**PRELIMINARY SAFETY AND ENVIRONMENTAL
INFORMATION DOCUMENT**

**HIGH-TEMPERATURE
GAS-COOLED REACTORS**

**NONPROLIFERATION ALTERNATIVE SYSTEMS
ASSESSMENT PROGRAM**

**U.S. DEPARTMENT OF ENERGY
ASSISTANT SECRETARY FOR NUCLEAR ENERGY**

Figure B-1. Gas-turbine HTGR thermal barrier classes.

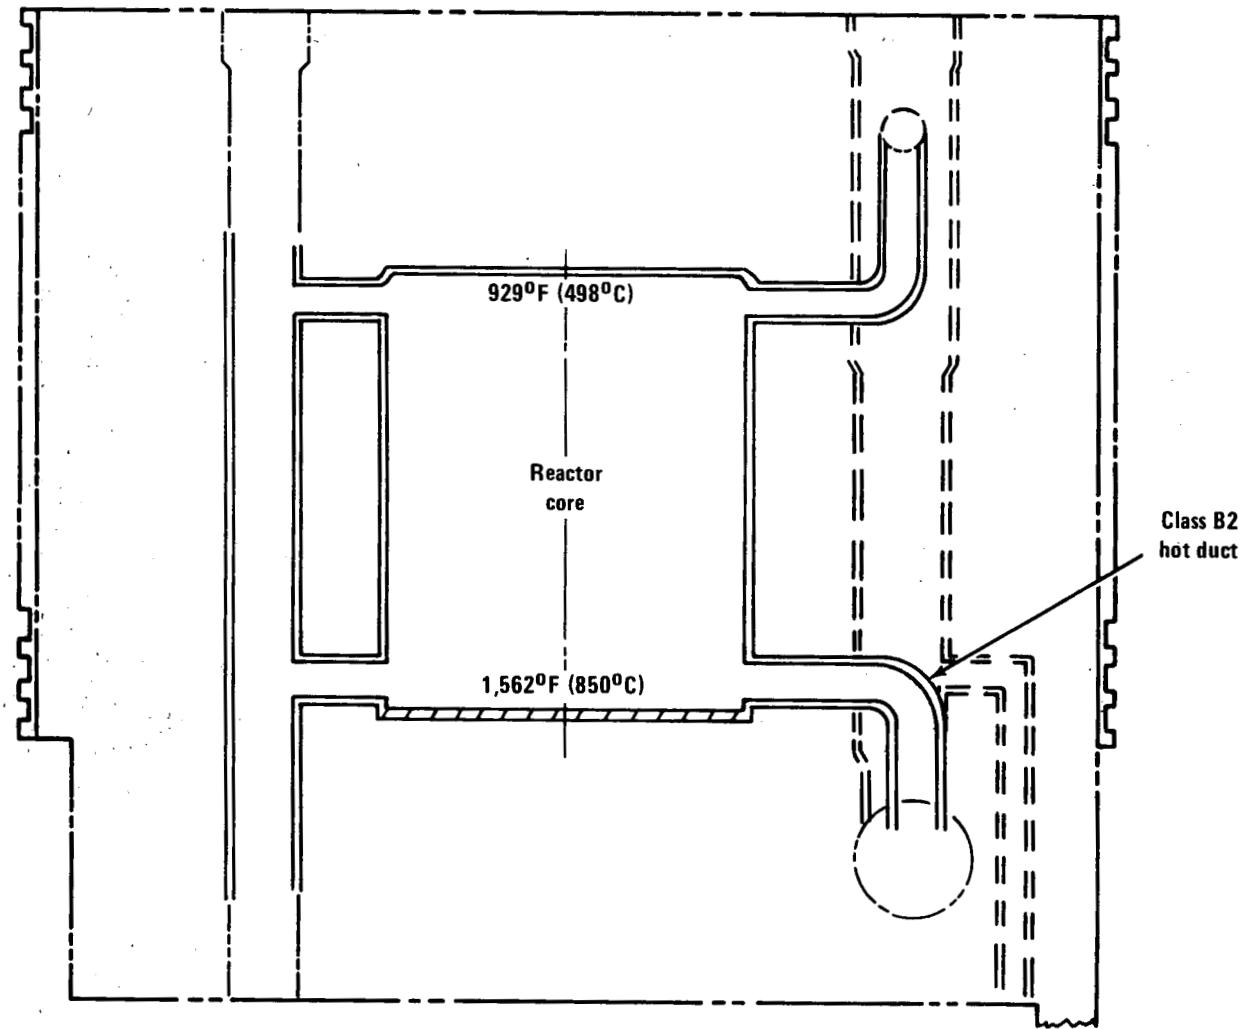
Response

Thermal and mechanical limits are given below for the thermal barriers, reactor internal components, liners, penetrations, closures, the PCRV, the reactor core, and control rods.

Four classes of thermal barrier are used in the HTGR. These classes of thermal barrier are indicated in Figure B-1 as a function of location in the primary coolant loop. Figure B-2 shows a typical Class A, Class B1, and Class B2 thermal barrier arrangement; the design concept for each of these three classes is the same, only the materials are changed. Figure B-3 is an elevation view of a Class C thermal barrier. This concept is significantly different from the other concepts in that hard ceramics are used.

Tables B-1, B-2, B-3, and B-4 give the temperature limits and structural limits for the Class A, B1, B2, and C thermal barrier structural components, respectively. The structural limits for Class A, B1, and B2 thermal barrier apply to metallic components. As indicated in Figure B-2, carbon-carbon is a candidate material for Class B2 thermal barrier. This material is not a metal and not a typical ceramic. Therefore, if this material is used, a new structural criteria will need to be developed. These limits are to be confirmed by research and testing programs.
